**BEFORE
THE OHIO POWER SITING BOARD**

In the Matter of the Application of	)	
Kingwood Solar I LLC for a Certificate	)	Case No. 21-0117-EL-BGN
of Environmental Compatibility and	)	
Public Need	)

**KINGWOOD SOLAR'S JUNE 1, 2021 RESPONSES
TO STAFF'S MAY 17 AND MAY 20 DATA REQUESTS**

Updated Figure 03-3

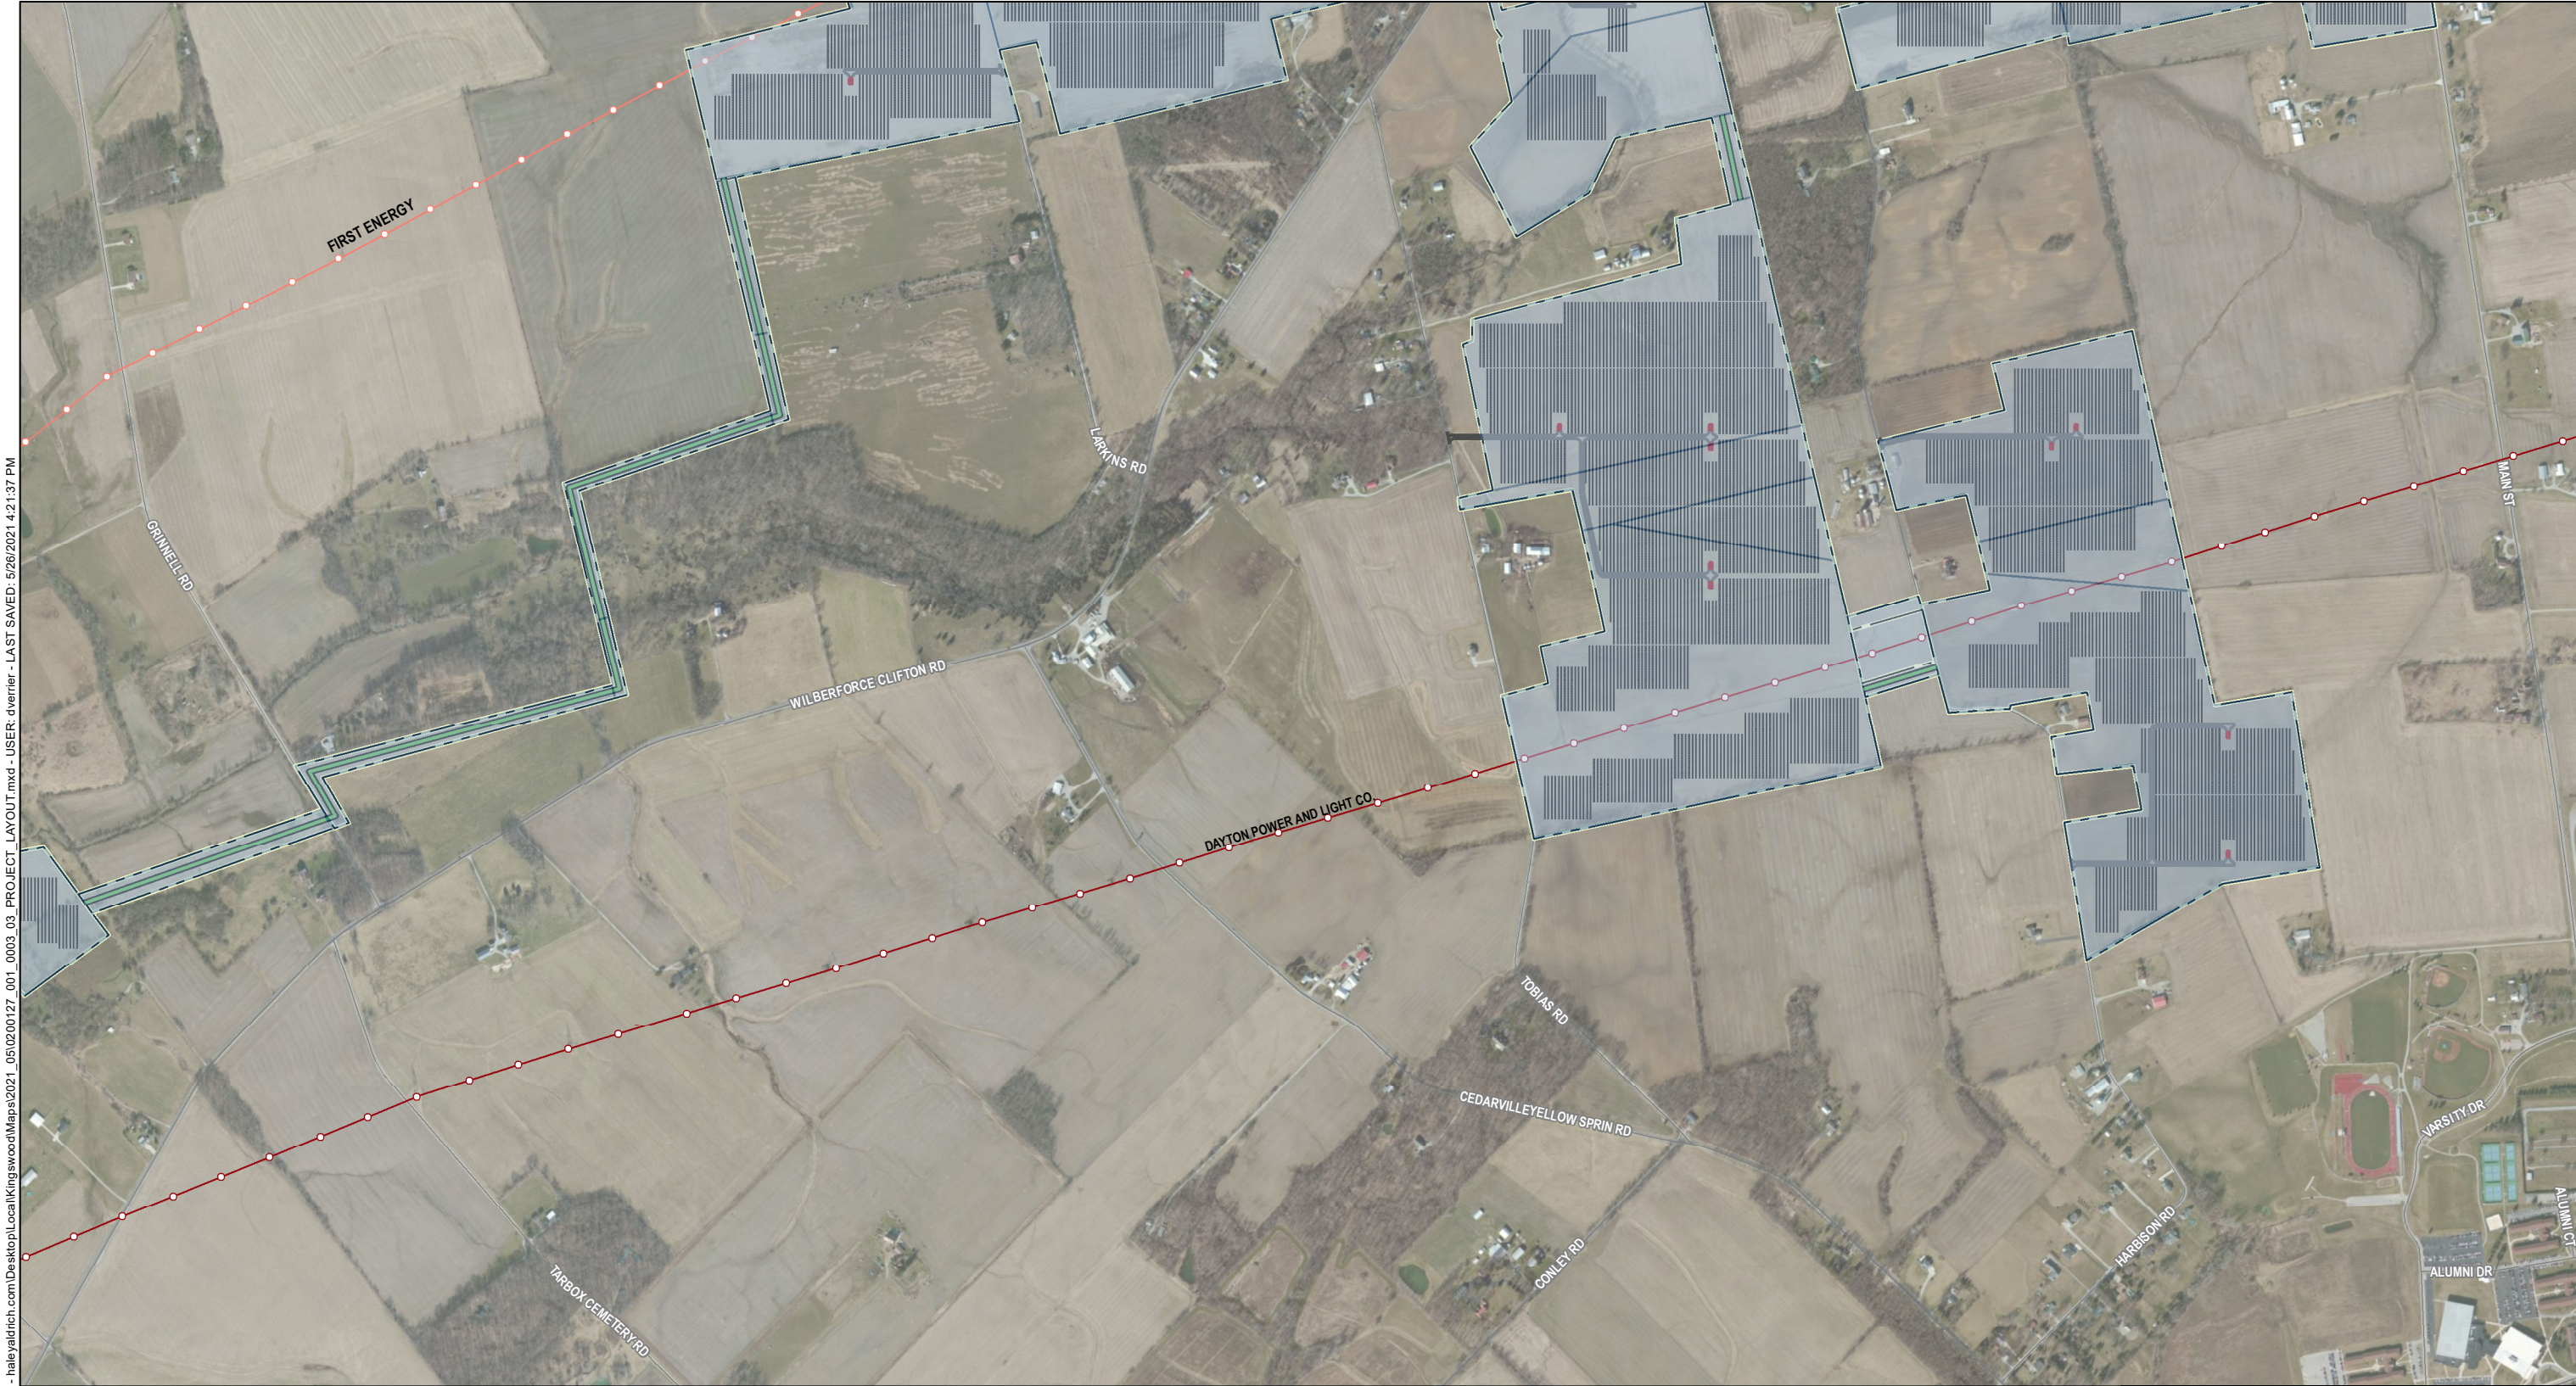
- 20. Please update Figure 03-3 (Project Layout) and other relevant facility mapping to reflect the proposed location of the gen-tie line referenced on page 1 of the Application and provide associated shapefiles.**

An updated Figure 03-3 is attached. The associated shapefiles will be provided separately to OPSB Staff.

No, the nearest residence currently measures more than 400 feet from the gen-tie line as shown in the updated Figure 03-3.
